Subject: Hydrogeologic Considerations Response
(justifications in response to DEHNR December 16, 1994 Memorandum letter)

Ecological Services, Inc. (ESI), on behalf of Mr. Larry Griffin, offers the following in response to additional hydrogeologic considerations outlined in Jim Bateson's December 16, 1994 memorandum.

Job #: ES-0675		North Mecklenburg Landfill		Well #: MW-3	Page 1 of 1
County: Mecklenburg	State: NC	Date Begin:	Date End:	Casing Height:	Land Surface Elevation:
Lat:	Long:	Drilled By: Graham & Currie		Static Water Level	
Grid Coord:		Logged By: Paul Banks		Development Method	
Tests:		Drilling Method: Hollow Stem		Sampling Method:	
Grout: 5% Bentonite		Seal: 6 - 8 ft		Gravel Pack: 80/20 Silica Sand (8 to 20 ft)	
Casing Type:		Diameter:	Depth: 0 - 10 ft	Hole Dia: 4"	
Screen Type:		Diameter:	Slot: 0.010 inch	Depth: 9 - 19 ft	Total Depth: 20 ft
PID/FID Reading (ppm)	Penetration Resistance	Depth (ft)	Lithology/Remarks	Well Completion	
		0		0

FIGURE: #10 PROPOSED
 MONITORING WELL
 LOCATION PLAN
 LARRY GRIFFIN
 N. MECK. LANDFILL
 HUNTERSVILLE, NC

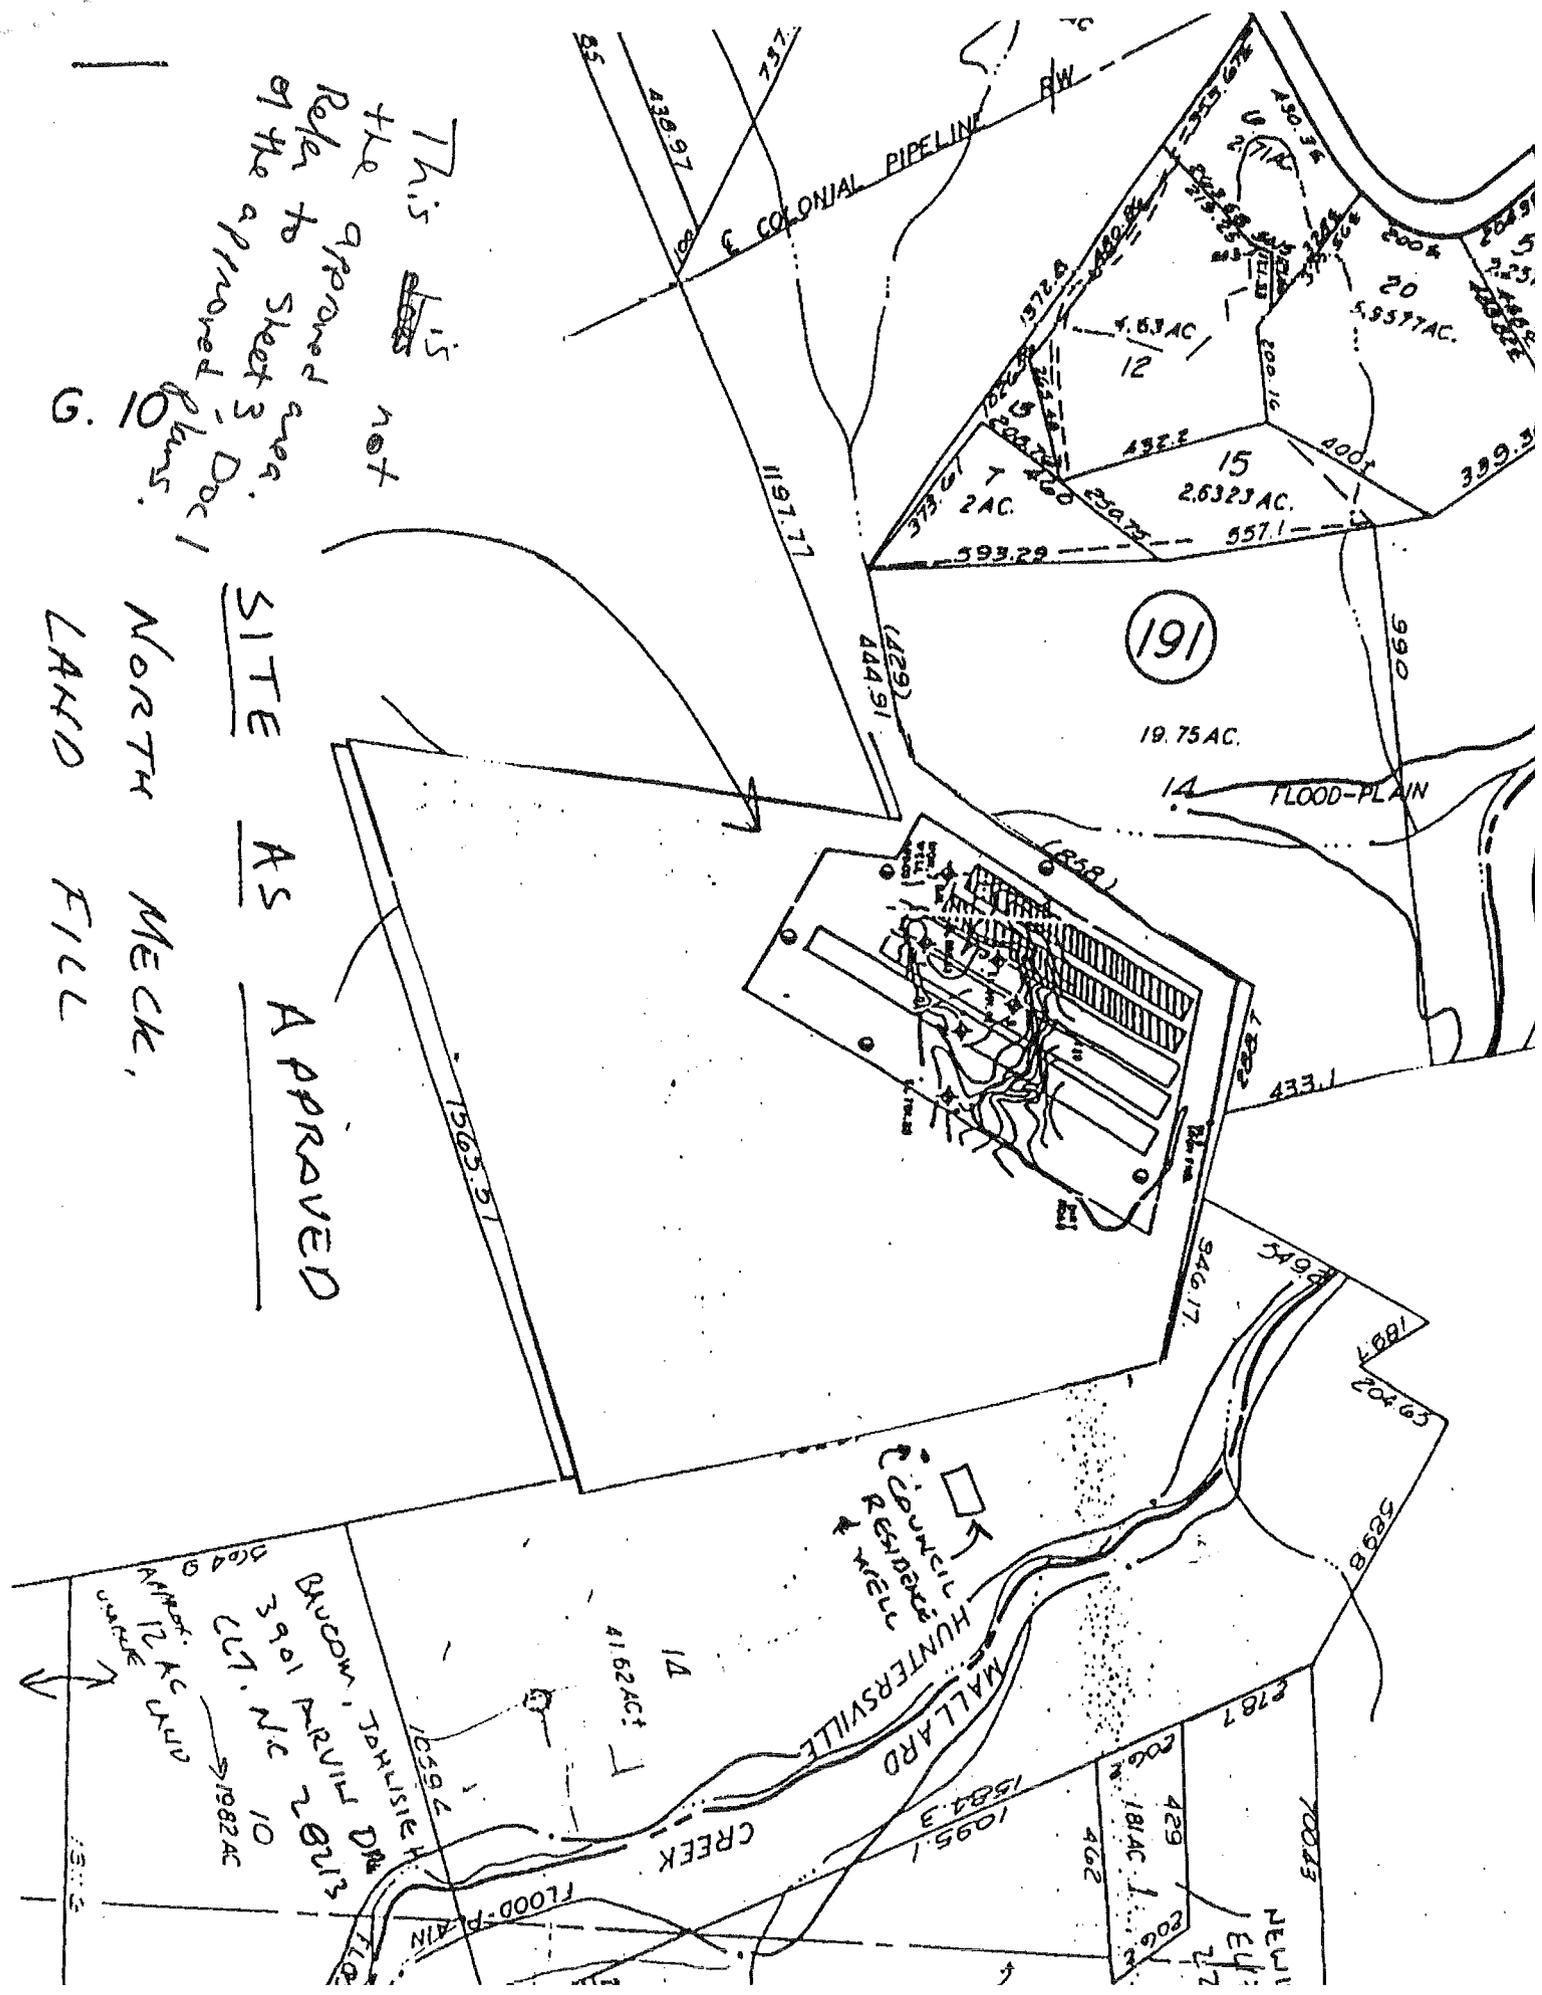
This is not the approved area. Refer to sheet 3 of the approved plans. Doc 1
